**LEESBURG BOARD OF ARCHITECTURAL REVIEW
STAFF REPORT**

**PUBLIC HEARING AND REGULAR MEETING: 19 NOVEMBER 2012
AGENDA ITEM 6f**

BAR Case No. THLP-2012-0114, TLHP-2012-0115, TLHP-2012-0116 and TLHP-2012-0117: Construction of porch roof and gazebo, installation of two signs and exterior painting for King's Tavern & Wine Bar

Reviewer: Kim K. Del Rance, LEED AP
Address: **19 S. King St.**
Zoning: B-1, H-1 Overlay District
Applicant/Owner: Fabian Saeidi, King's Tavern & Wine Bar

October 2012 photo (now King's Court)

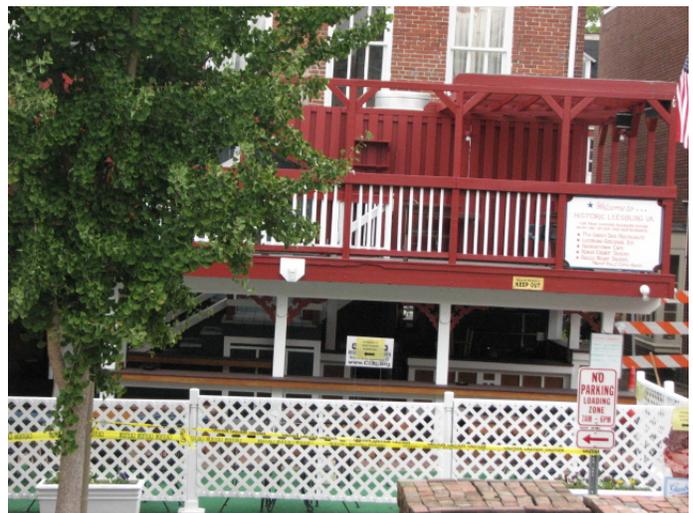
Wall sign above back door under new porch roof

Projecting sign at back next to new porch roof

Back porch roof with wall sign underneath

New plastic lattice fence

The new open porch consists of two simple square columns and a small shed roof to protect the doorway and small slab patio from the elements. The shed roof is simple, but it is unclear what the material is as staff has not been able to visit the site closely and that information has not been provided to staff. It appears not to be a standing seam metal roof that matches the existing roof, which would be most appropriate to match the existing roof material.

The new wall sconces are of the proper scale and placement relative to the doorway, but the light source is visible and the fixture is utilitarian such as one would find at a back door of a residence, not an entry to a downtown restaurant.

The freestanding gazebo placed on the asphalt lot behind the primary structure is in the correct location, but it is not subordinate to the simple brick building with panel doors and standing seam metal roof. The gazebo would be appropriate as back yard feature on a residential lot, in a public space or a garden, not as supplemental covered seating for a restaurant on this site with this architecture.

Plastic lattice is not a traditional fence material both as a material and as a pattern for fences.

The rear door, if a direct entry to the restaurant, may qualify for a wall sign and since there is a space located above the door suitable for a small wall sign the BAR may find the location acceptable. However, the size and shape of the sign does not relate to the space above the door. A wall sign designed to fit the space may be appropriate to be above the door, otherwise the existing wall sign should be placed below the top of the door and to one side if the Board finds that the sign is appropriate.

The projecting sign is located at the rear of the building when the main entrance is on King Street where the projecting sign should be located.

- The porch roof will be reroofed with a standing seam metal roof to match the existing roof on the primary structure
- the gazebo will be removed and the plastic lattice will be replaced with a simple wood fence
- the lighting fixtures will be replaced with suitable fixtures to be approved by staff under the normal administrative review process.
- all applicable Town and County Zoning and Building Permits must be obtained prior to proceeding with work

Staff recommends removal of the window sign and approval of **TLHP-2012-0115** for the wall sign to be lowered to the side of the rear entry door or redesigned to fit into the space above the door.

Staff recommends approval of **TLHP-2012-0116** for the projecting sign to be moved to the front entry door.
